## Project Advisory Committee (PAC) Meeting No. 2

CCRPC Colchester/Riverside/Barret/Mill Scoping Study / 195311163

Date/Time: April 26, 2016 / 5:30

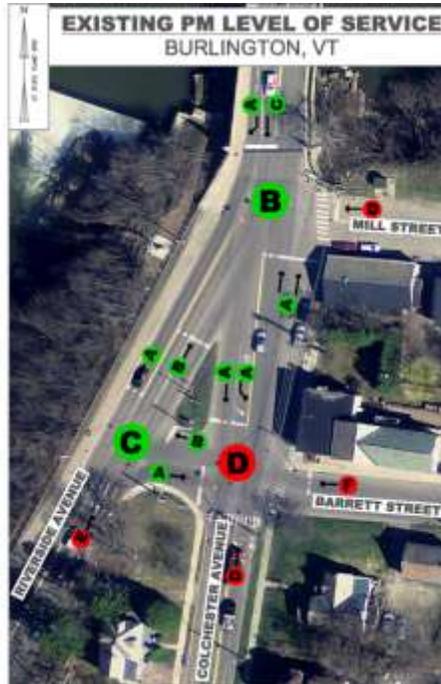
Linda believes a pedestrian bridge in the backlot at the tree line would be a good amenity for Chace Mill users.

Nicole Losch of the CCRPC agrees that it would provide great connectivity across the river. She brings the groups focus back to traffic congestion.
